NL-14-1197

Edwin I. Hatch Nuclear Plant
License Amendment Request to Revise Technical Specifications to
Add a Critical Instrumentation Electrical Bus in LCO 3.8.7

1.0 SUMMARY DESCRIPTION

Critical Instrumentation Bus and Inverter

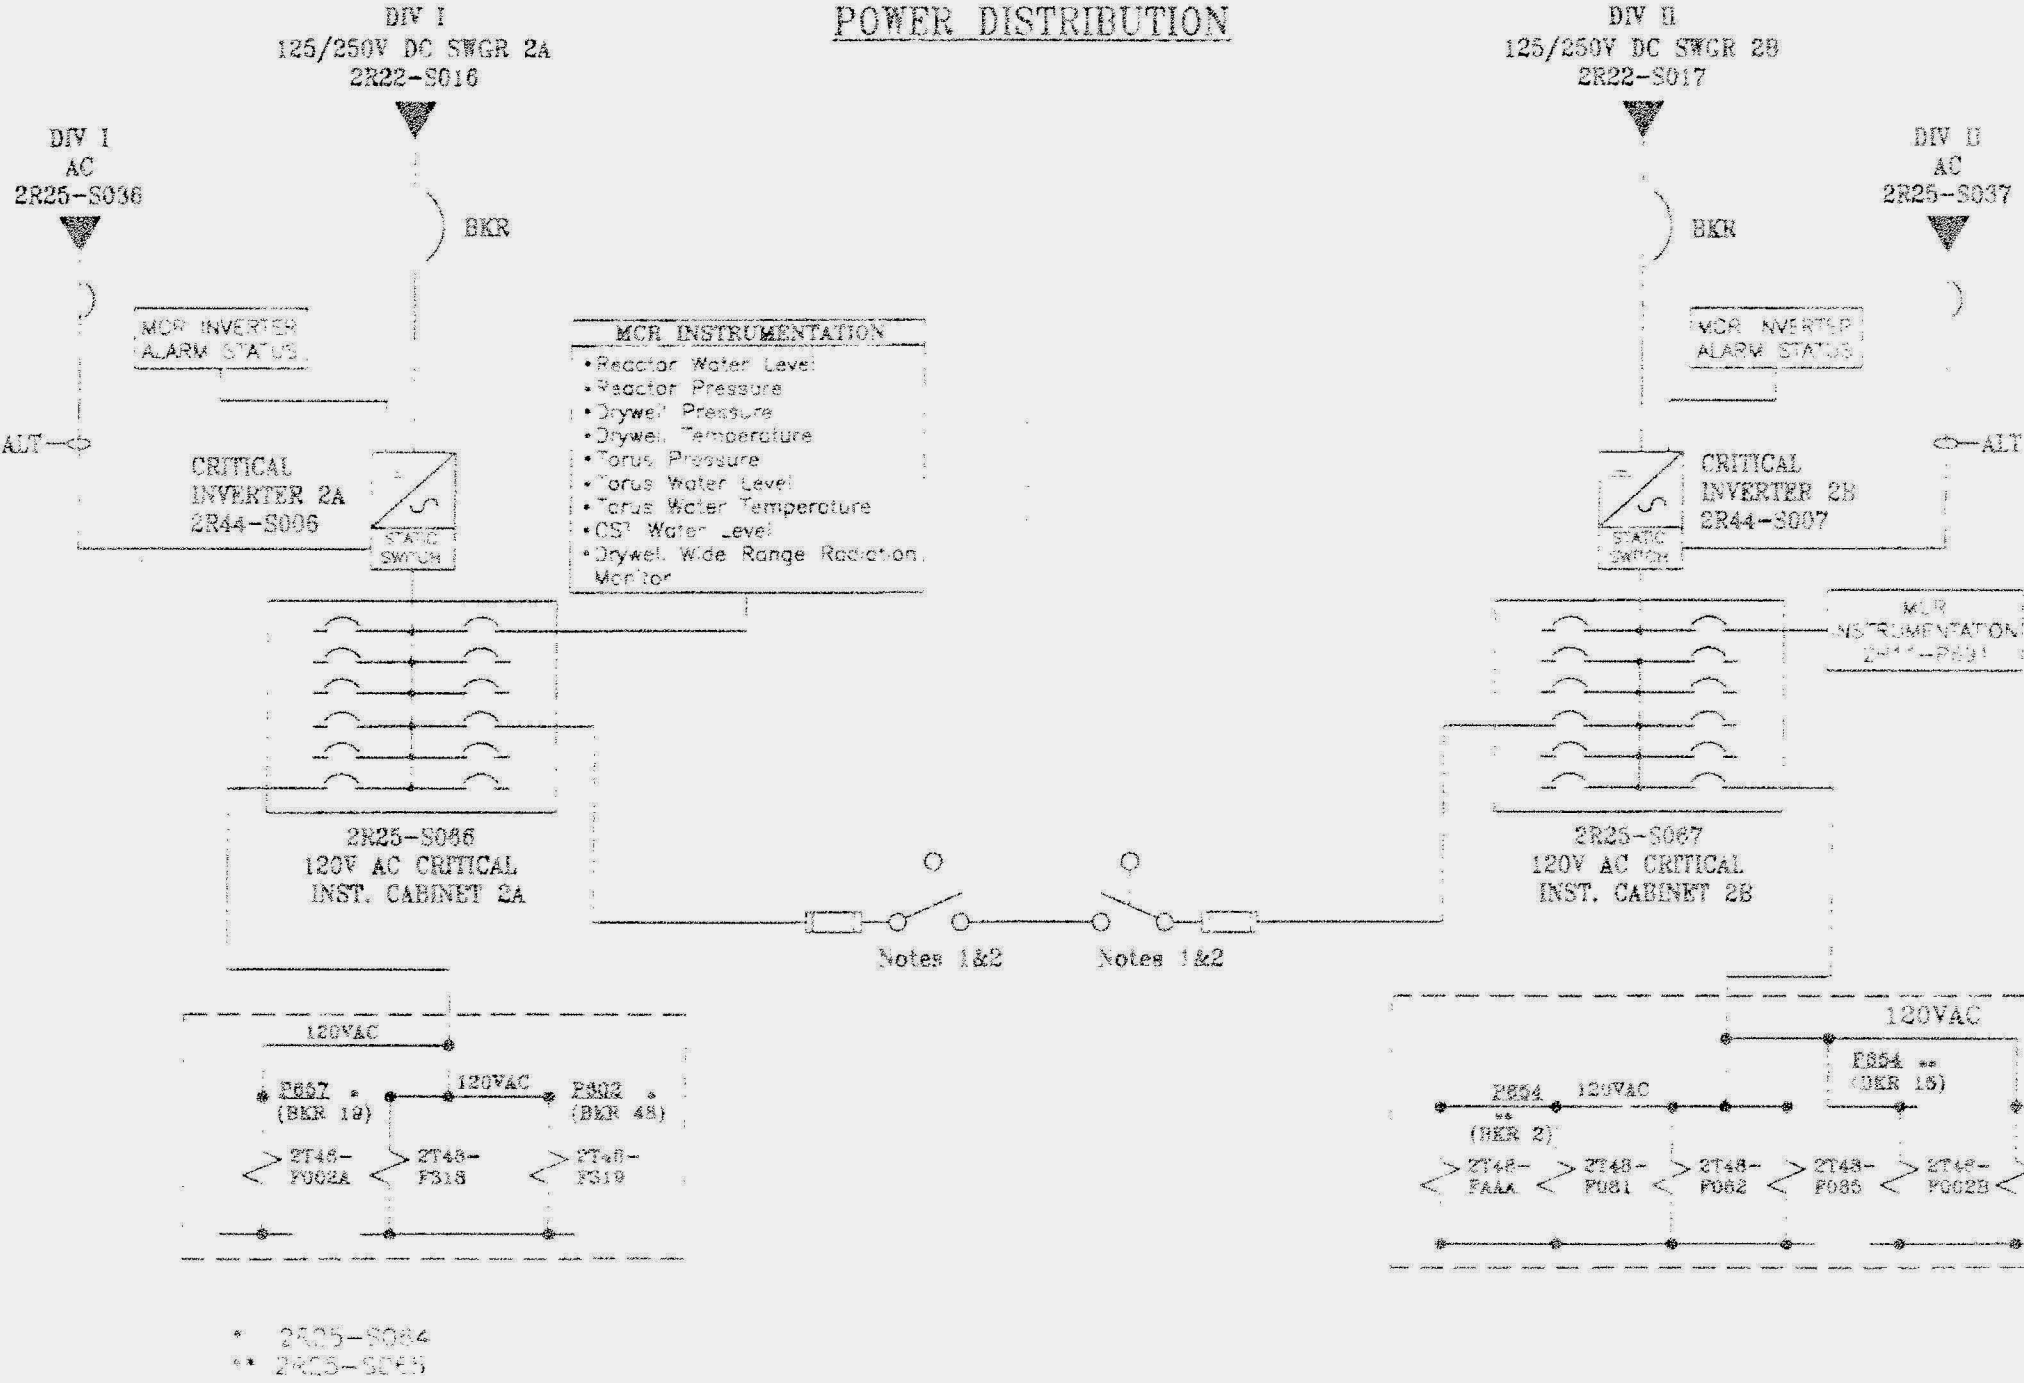
The new divisionally separated critical instrumentation buses will each be supplied power via a safety related DC/AC inverter which in turn will receive its primary power from the safety related DC station service buses (R22-S016 and S017). (Attachment 1 provides an information drawing showing the latest Unit 2 design for the inverter and the critical instrumentation bus. The Unit 1 design will be similar). Alternate power to the new inverters will be provided by the existing essential AC cabinets, through a bypass switch internal to the inverter. Back-up power to the inverters will ensure that power to equipment supplied by the inverters is not lost upon DC system maintenance. A cross tie between divisions will also be added to provide further diversity in the power supplies.

Therefore, highly reliable components will provide power to the instruments on the critical instrumentation bus. This is important since these instruments will serve the operator during design basis events as well as BDBEEs. Furthermore, the inverters and instrumentation buses will be divisionally separated to protect against single failures. Cross tie between divisions will be possible via two seismically mounted fused disconnect switches (Attachment 1). These switches will be normally open and will be operated only during an extended loss of offsite power BDBEE, concurrent with a single division failure. These switches will therefore be open during normal operation, and thus during the start of any design basis event.

- 1. Normally open fused disconnect switch. Fuses shall never be in place during normal operation.
- 2. Fused disconnect switch operation is to be performed under administrative control and during extended SBO only.
